STAFF REPORT

Community Planning and Preservation Commission Certificate of Appropriateness Request

CITY FILE NO.: 20-90200015

2855 8th Avenue North

Figure 5: Present condition of attic window, replaced with board.

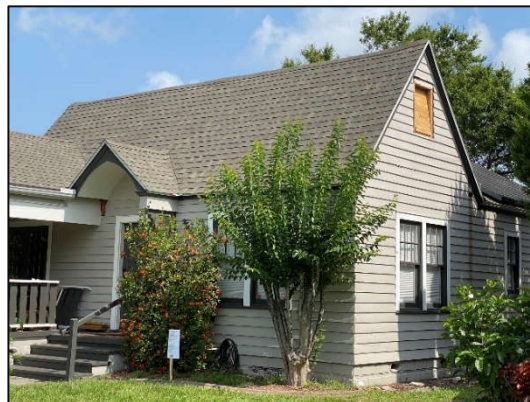
Consistent The subject property is a contributing resource within the Kenwood Section – Northwest Kenwood Local Historic District. The alteration will replicate the historic window's configuration. A degree of change to the window frame's profile will be necessary to accommodate the new unit's impact resistance. Staff finds this appropriate given the lack of a present historic unit, and the window's second-story placement, which would make alternative hurricane protection measures difficult.

Generally consistent The proposed replacement window will be the same size as the original and replicate the original one-over-one configuration. The new materials proposed to be used, as noted above, are considered acceptable due to the lack of a historic unit present and added protection to the property created by the impact-resistant unit in an area that would be difficult to secure to severe weather events.

Consistent The window previously installed in this location has been missing since February 2020, if not earlier. The installation of a permanent covering in this building opening is critical to the long-term preservation of the historic resource, particularly as Florida's wet season approaches.

4. *Frame size, shape and exterior trim. The replacement window shall be the same size and shape as the historic window and opening. Historic openings shall not be altered in size. Existing, exterior trim shall be retained, where practicable;*
Consistent The previously-installed trim appears to have fallen off or been removed. Staff recommends that its replication with wood be included as a condition of approval.

1. Windows will be installed to be setback within the wall plane and feature a reveal of at least two inches.
2. Wooden exterior casing and trim will be installed to replicate that of matching attic window at north elevation.
3. All other necessary permits shall be obtained. Any additional work shall be presented to staff for determination of the necessity of additional COA approval.
4. This approval will be valid for 24 months beginning on the date of revocation of the local Emergency Declaration.

1. East-facing window

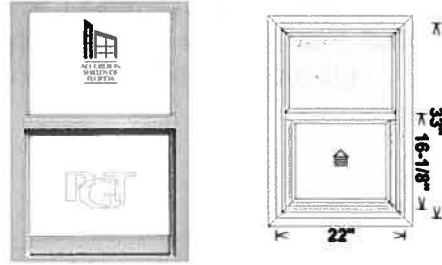
PGT 5500 Single-hung window, no grids - in keeping with what was there previously.
This window was not installed or maintained correctly by previous homeowners or builders.
It rotted, fell out and broke. Restoration is not an option.
